WILLISTON DEVELOPMENT REVIEW BOARD STAFF REPORT

DP 24-09

Benedetto Subdivision

1318 Butternut Road

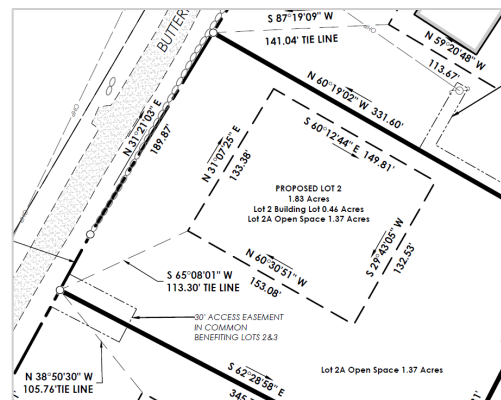
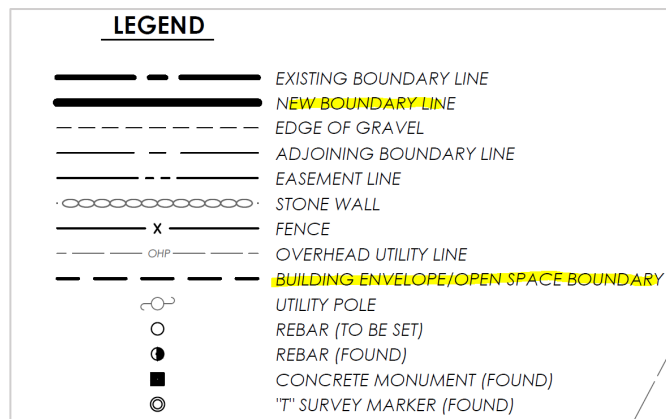
At Final Plans, the plat must be revised. Per WDB 31.7.7, open space must be platted separately. Per 31.7.8, “...open space ...must be monumented in accordance with the requirements of 12.4.1.5 with the same degree of accuracy as a building lot.” For parcels larger than 10.5 acres, open space cannot be designated with a building envelope and open space area within the same lot. The narrative letter describes a 3-lot subdivision where the applicant is intending to create 6-lots. The plat needs to be revised to eliminate the ‘building envelope/open space boundary’ designation and show all proposed boundaries as ‘new boundary line.’ The plat must be revised to include survey monuments for the house lots same as the open space lots in conformance with WDB 12.4.1.

17. This decision runs with the land and is binding on any future owners, heirs, or assigns of the subject property.
18. **House lots and open space lot(s) shall be platted and monumented in compliance with WDB 12.4.1.5 and 31.7.8.**
